**Tip Cap / Tip Webbing
Safety Directive -SD501
Status: Mandatory
All Wings grounded till complied**

Date: July 10, 2024

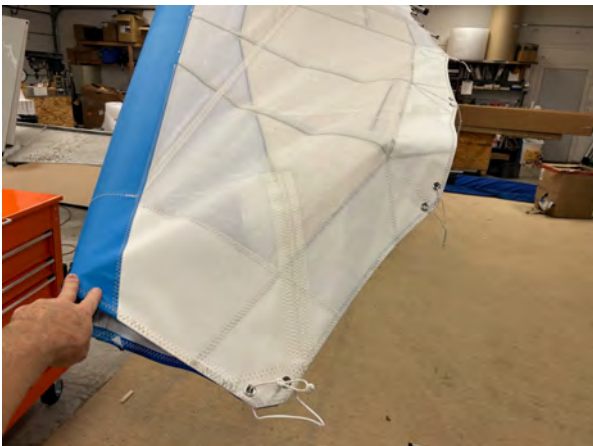
We had a run of tip caps that ran small on the body and the rim.
ID 1.838" to 1.860"
They should be 1.884 to 1.891 (ranging .025 to .45 smaller)
Your cap body should not be less than 1.884

Tip Cap pressed down into the Shim and alum edge can cut the Webbing

If your tip caps are in spec and webbing is just slightly worn you can medigate any farther wear by doing 2 tasks: 1- File the shim or LE tube to be more rounded and smooth
2- Put a piece of 1"x1" adhesive LOOP Velcro on the edge Or heavy tape. See picture
